Contract #: 04-0120F4Cty: SF/ALA Rte: 80 PM: 13.2/13.9File #: 69.25B**QUALITY ASSURANCE -- NON-CONFORMANCE REPORT****Location:** Changxing Island, Shanghai, P.R. China**Report No:** NCR-000980**Prime Contractor:** American Bridge/Fluor Enterprises, a JV**Date:** 21-Feb-2011**Submitting Contractor:** Zhenhua Port Machinery Company, Ltd (ZPMC), Changxing Island**NCR #:** ZPMC-0938**Type of problem:**

**Reference Description:** ZPMC performed joint change to CJP without following proper welding procedures**Description of Non-Conformance:**

**Subject:** NCR No. ZPMC-0938

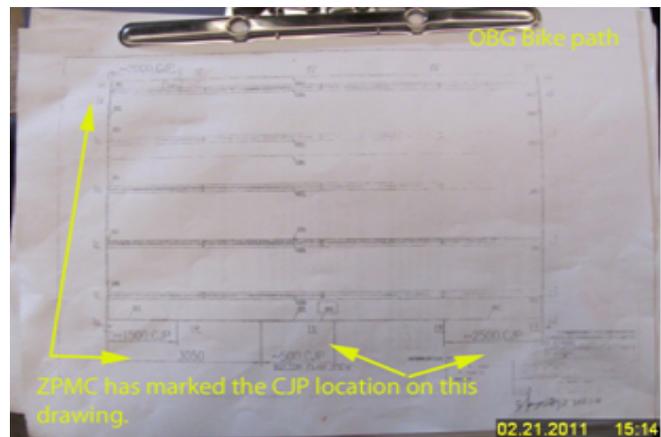
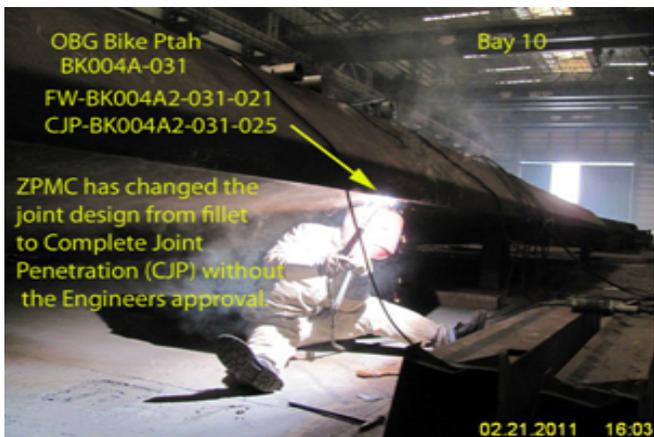
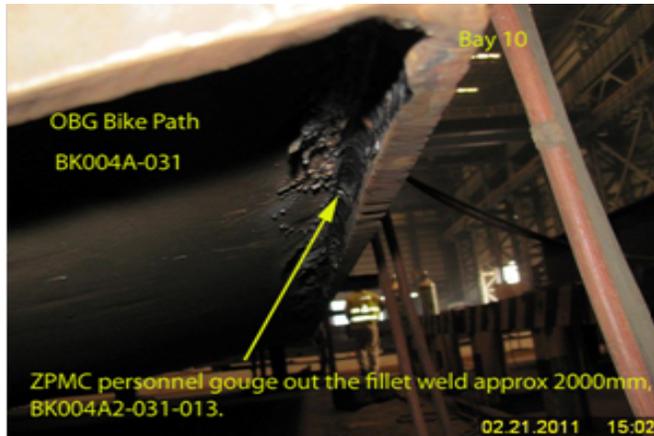
During the fabrication of the Orthotropic Box Girder (OBG) Bikepath (BK) BK004A-031, this Quality Assurance (QA) Inspector discovered the following:

- ZPMC has changed a weld joint detail from fillet to Complete Joint Penetration (CJP) because the fit-up of the root exceeded 5mm.
- ZPMC indicated that the work is performed per Submittal 200R2.
- QA observed that Submittal 200R2 was not followed.
- ZPMC welded single bevel welds without backing bar and with no access to perform backgouging.
- ZPMC used "WPS-345-SMAW-4G(4F)-Repair" for the work which is not appropriate for these new CJP joint.

- Without Engineer's approval, ZPMC is changing these welds from fillet to CJP only in certain sections of the welds, thus they are not continuous CJP with continuous backing.
- The fillet welds observed are BK004A2-031-013 and 021.
- The Y locations for the changed CJP welds on BKPL6A are:
  - 0mm-1500mm, 3050mm-3550mm and 6520mm-9020mm for BK004A2-031-013.
  - 0mm-2000mm for BK004A2-031-021.
- ZPMC identified the new CJP weld IDs as BK004A2-031-024, and BK004A2-031-022, 023, 025.
- The material is A709 Grade 345 Non Seismic Performance Critical Member (Non SPCM).
- The approved drawings, BK004A, specified fillet welds at these locations.
- The OBG Bikepath is located in Bay 10.

**Reference Resolution:** Per the RFI, ZPMC and ABFJV has confirmed that reinforcing fillet on both welds exceeds 6mm.

Per the RFI, ZPMC and ABFJV has confirmed that reinforcing fillet on both welds exceeds 6mm. Per the RFI ZPMC is providing MT of the root pass of this weld and MT of the cover pass as well. Based on this ZPMC requests closure of this NCR.

This proposed resolution is Accepted with Action Pending. The NDT documentation is acceptable; however, ZPMC has not addressed the cause for apparent failure of Quality Control to identify the deficiency nor provided documentation of the steps/actions taken by the Quality Control Manager to prevent future occurrences.

As-Built Gap  
(Pre-Weld condition)

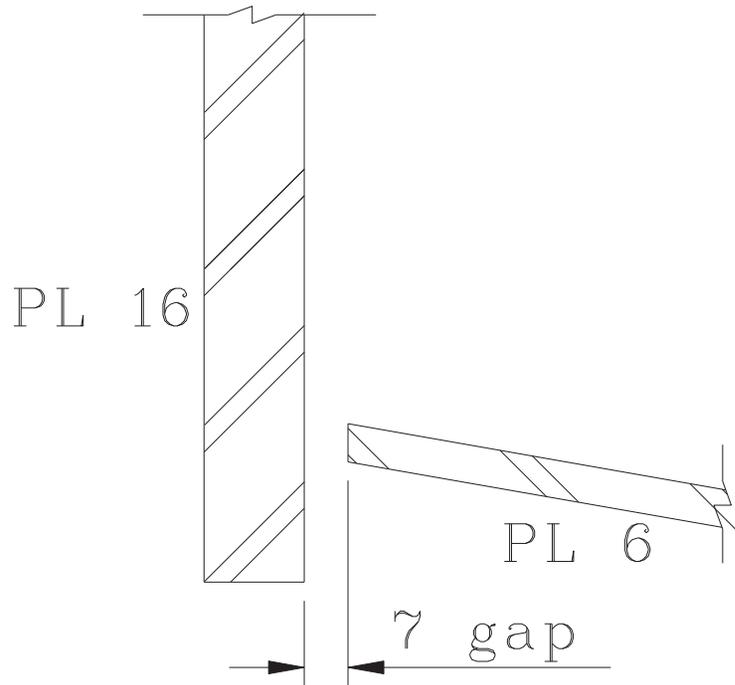
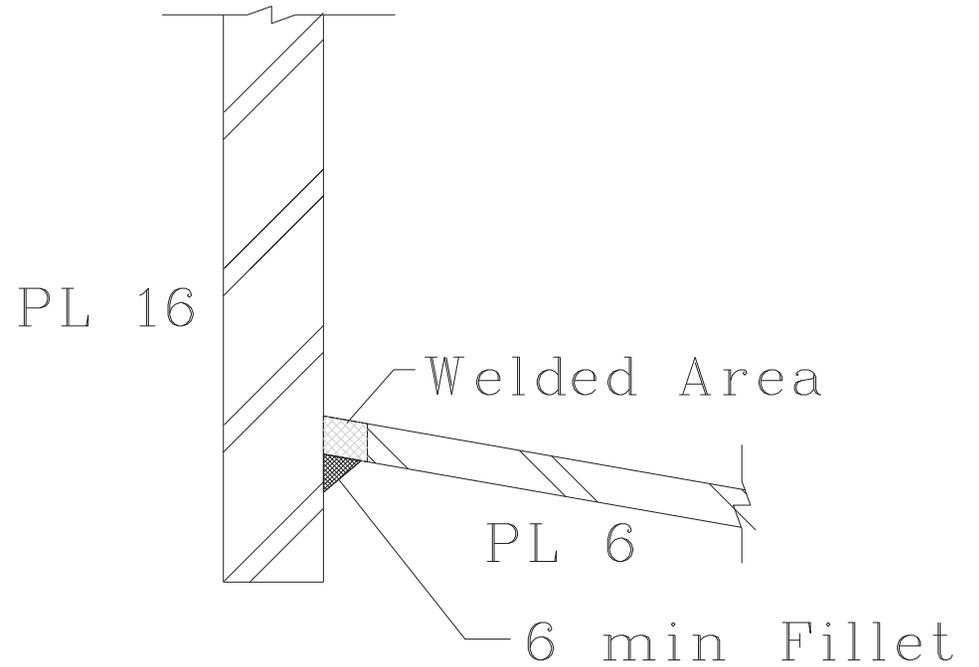
In response to NCR #: ZPMC-0938, ZPMC did receive previous approval to change fillet welds BK004A2-031-013 and -021 into CJP welds BK004A2-031-024 and BK004A2-031-022, -023, -025 under AFC-CAL-TRN-007772. However BK004A2-031-024 and BK004A2-031-022, -023, -025 were not performed according to an approved WPS. As a repair could be more detrimental to the component than the current condition, ZPMC proposes to leave the weld joints as-is. Results of 100% MT of root pass and 100% MT of cover pass were both found to be acceptable. Please confirm if this proposal is acceptable.

To facilitate fabrication, the Contractor's proposal to leave the weld as-is is acceptable on a fit-for-purpose basis, provided that the reinforcing fillet of the as built weld is 6mm minimum. See attached sketch.  
Thanks.

Acceptable Condition
